WBN-TS-04-05

WATTS BAR NUCLEAR PLANT (WBN) UNIT 1 - TECHNICAL SPECIFICATION
(TS) CHANGE NO. 04-05 - 125 VOLT (V) DIRECT CURRENT (DC)
ELECTRICAL POWER SUBSYSTEM

TVA EVALUATION OF PROPOSED CHANGE

Diesel Generator Battery Sketch
Top View

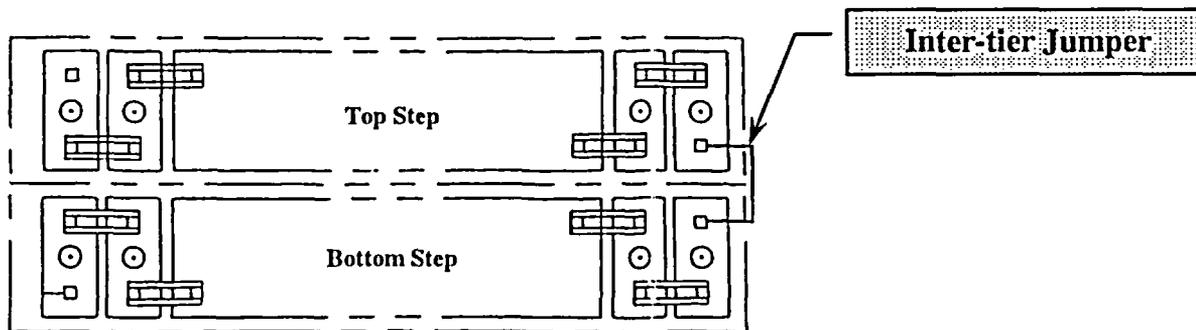
This letter is a request to amend Operating License NPF-90 for WBN Unit 1. The proposed license amendment will revise the Technical Specification (TS) to remove the term "inter-rack" and associated wording from Surveillances 3.8.4.6 and 3.8.4.10 for the 125 Volt (V) Direct Current (DC) Electrical Power Subsystems of the Emergency Diesel Generators (DGs). The TS change will clarify that the one jumper cable between battery cell tiers is the "inter-tier" jumper cable (see sketch below) by omitting all other references to inter-rack since the intent of both terms was to test the inter-tier jumper cable connections. Inter-rack is an incorrect term for the associated DG battery design.

The proposed change will revise TS Section 3.8.4, "DC Source-Operating," by revising Surveillance 3.8.4.6 and 3.8.4.10 to remove the phrase " $\leq 50 \text{ E-6 ohm}$ for inter-rack connections" from the listed connection resistance measurement specified therein. TVA is proposing this change to remove ambiguous wording.
